March 26, 1992
LD-92-043

Docket No. 52-002

Subject: Structural and Geosciences Engineering

This letter transmits the single remaining outstanding RAI response (#230.1). Although responses have now been submitted for all 1463 RAIs, we will continue to work with NRC staff to resolve any comments and to supplement those responses which referenced future work (e.g., Shutdown Risk and PRA).

Figure 230.1-1 - Variation of Spectral Accelerations with Depth of Soil to Bedrock
(Free-field Ground Surface)

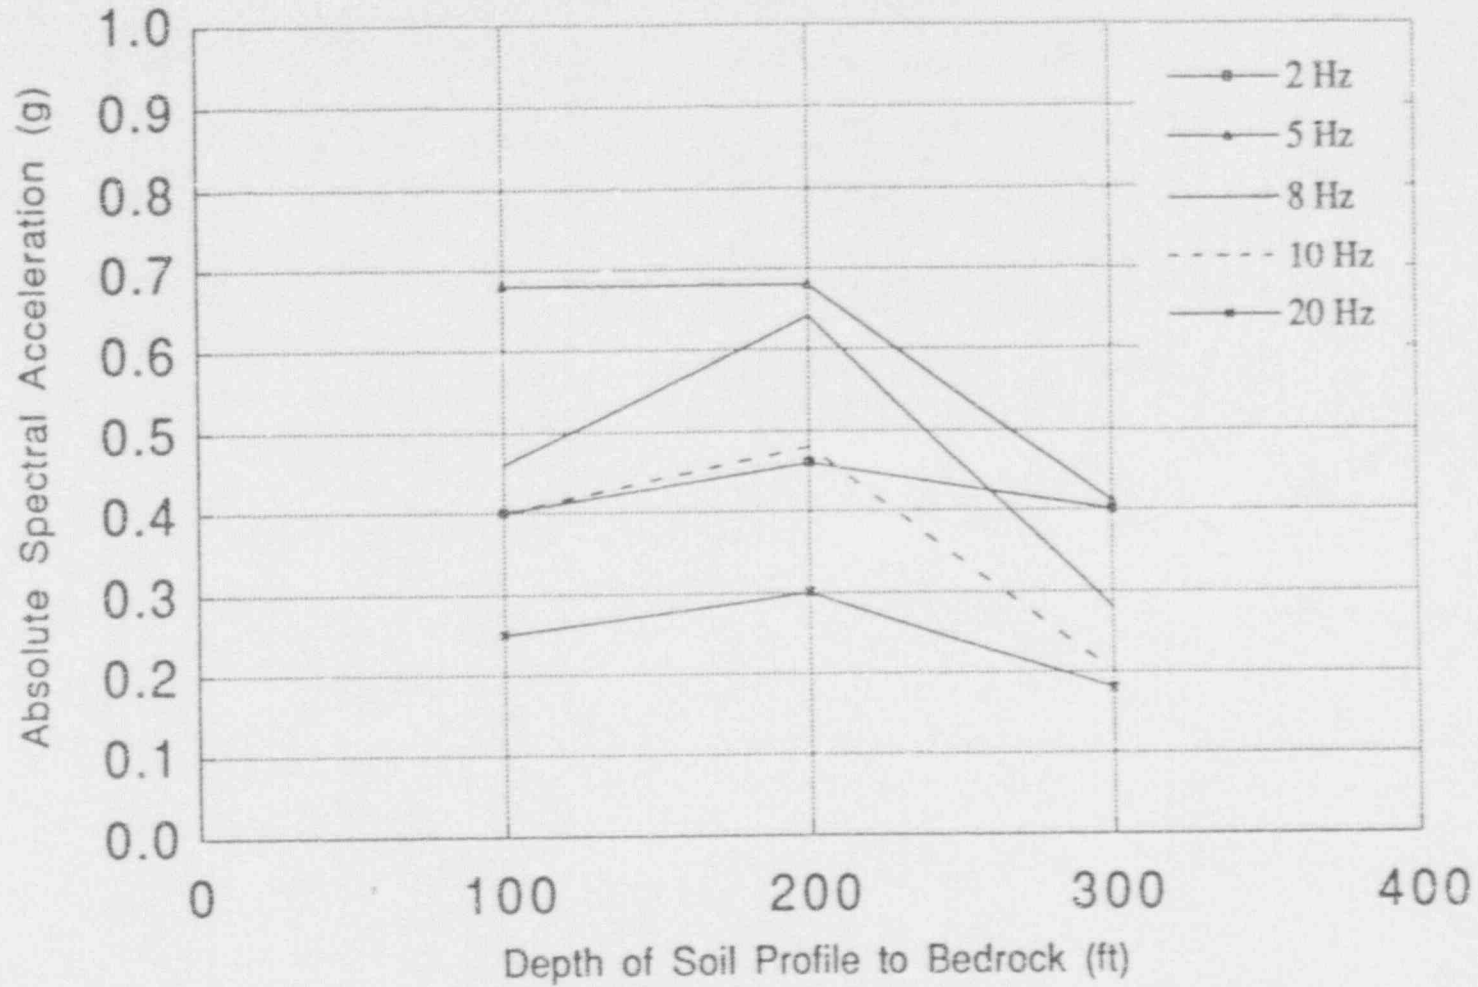
Section 2.5 - There are many nuclear power plants in the U.S. built on deep soil sites. Justify the argument that soil sites having a total depth to bedrock greater than 300 feet (Figure 2.5-1) are covered by the twelve soil cases analyzed as stated in Page 2.5-2.

Spectral accelerations at selected frequencies are plotted in Figures 230.1-1 and 230.1-2 as a function of soil depth to bedrock. Figure 230.1-1 corresponds to accelerations at the free-field ground surface and Figure 230.1-2 corresponds to spectral accelerations at the free-field foundation level. In both plots it is shown that spectral accelerations show significant decrease for the 300 ft. soil case, which is indicative of the trend that accelerations follow with increasing depth to bedrock. Therefore, deep soil sites are enveloped by the twelve soil cases considered in the soil analyses.

Fig. 3.7-2 Calculated Horizontal & Vertical Spectral Ordinates at the Foundation Level for Case A-1

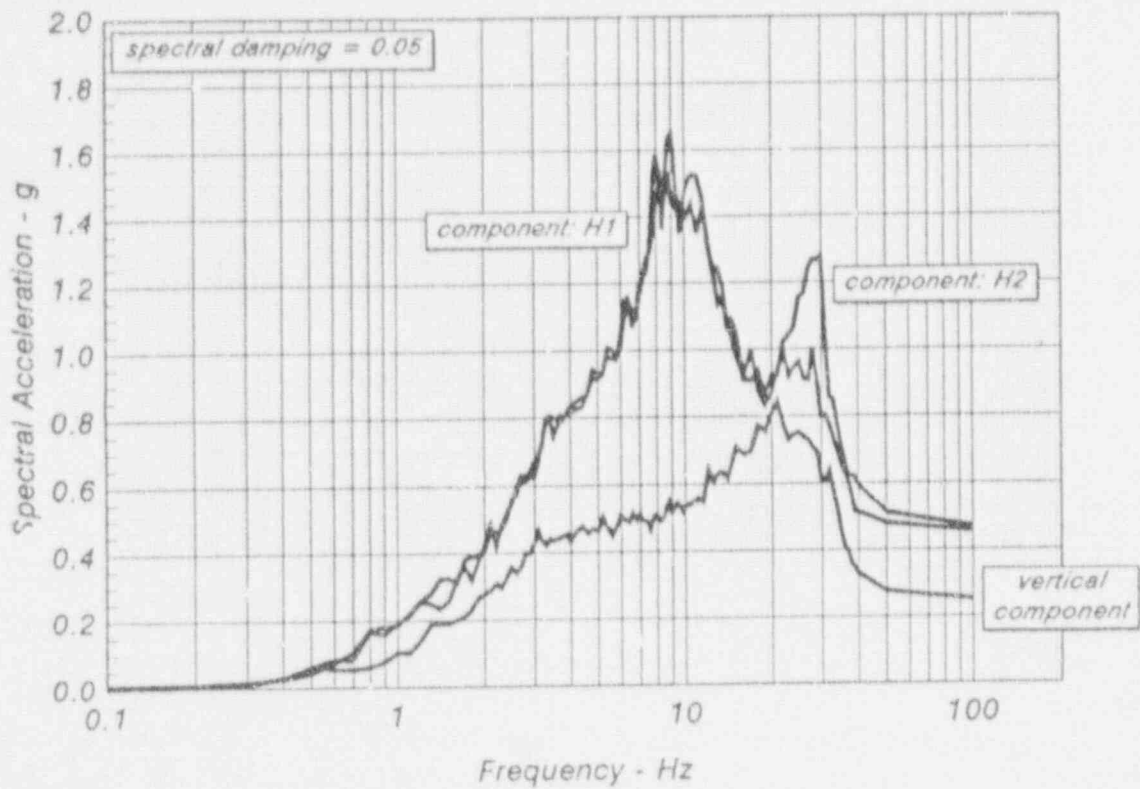
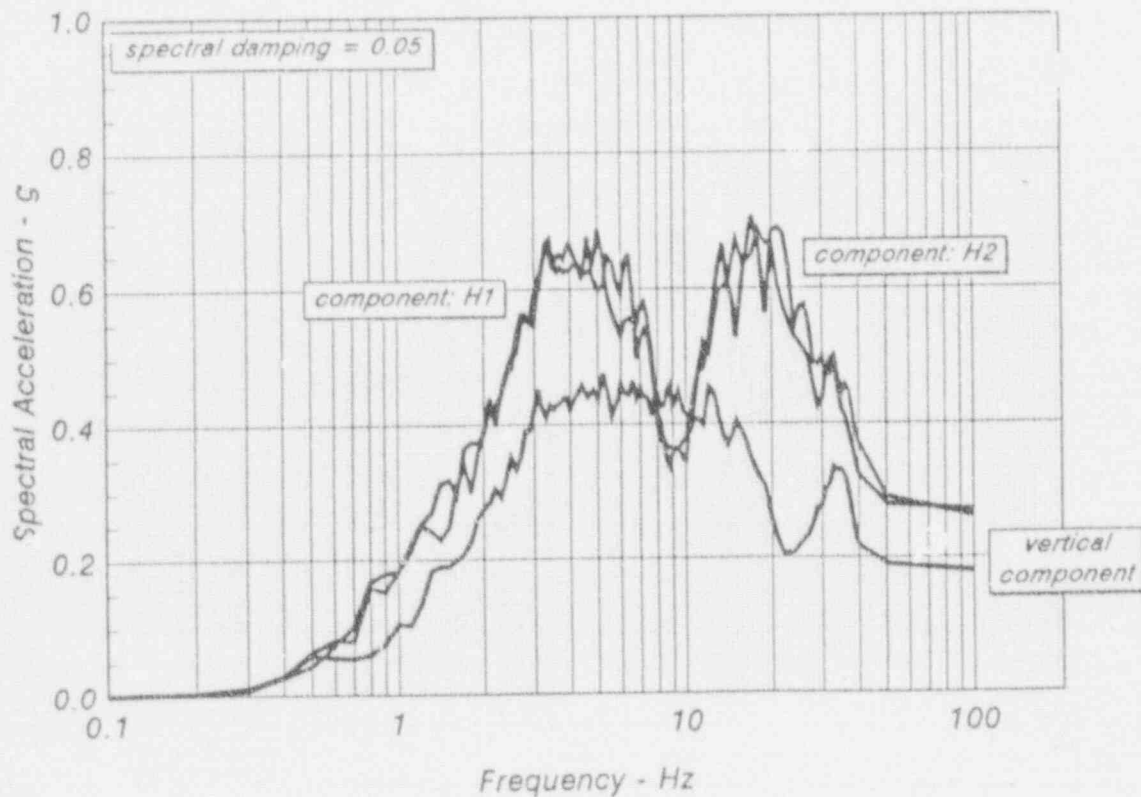
Section 3.7.1.1 - Explain why Figure 3.7-2 is practically identical to Figure 3.7-1. In Case A-1 (Figures 3.7-1 and 3.7-2), the bedrock is at the foundation level. Explain why, in the high frequency range, the horizontal and vertical spectral values converge to 0.5g and 0.3g, respectively in both the cases.

The contents of Figs. 3.7-1 and 3.7-2 are identical because they both are for the calculated spectral ordinates at the ground surface for Case A-1. This situation has been corrected and the attached figures include the correct information at the ground surface and at the foundation level for Case A-1.

Figure 220.7-1 - Comparison of SRP PSD and Average PSD of Soil Case B3.5

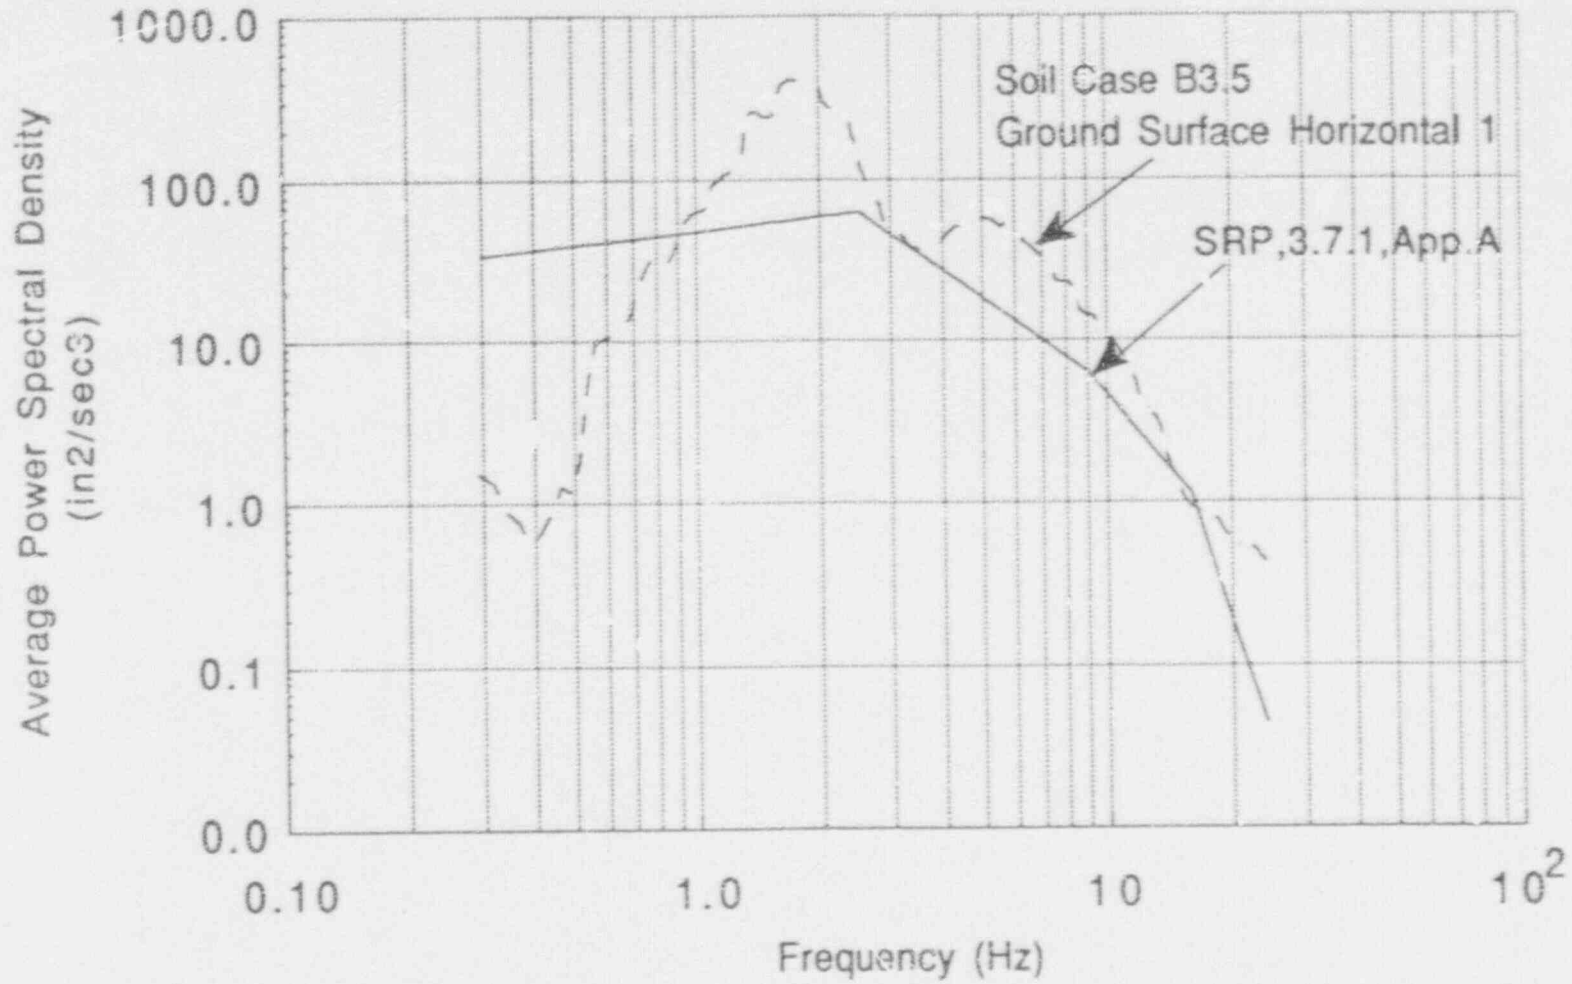
Section 3.7.1.1 - This section states that "For the time history method of analysis, three design time histories are generated that are consistent with the design rock outcrop spectra at the free field." Explain why these time histories instead of the time histories consistent with the spectra presented in Section 3.7.1.1 are used in the time history method of analysis. Also, compare the PSDs of the 3.7.1.1 spectra with the provisions of Appendix A of SRP 3.7.1.

the average PSD was computed over a frequency band width of $\pm 20\%$ centered on each frequency. The comparison of the B3.5 PSD with the SRP, 3.7.1, App. A target PSD is shown in Figure 220.7-1. The SPP PSD is normalized to a 0.35g peak acceleration, since 0.35g is the peak acceleration of the B3.5 soil case at the ground surface.

Figure 220.7-1 shows that the B3.5 PSD conservatively exceeds the SRP PSD at all frequencies above 0.9 Hz. The frequency range below 0.9 Hz has no structural significance. Also, there are softer soil profiles with surface motions that have more power in the frequency range below 0.9 Hz.
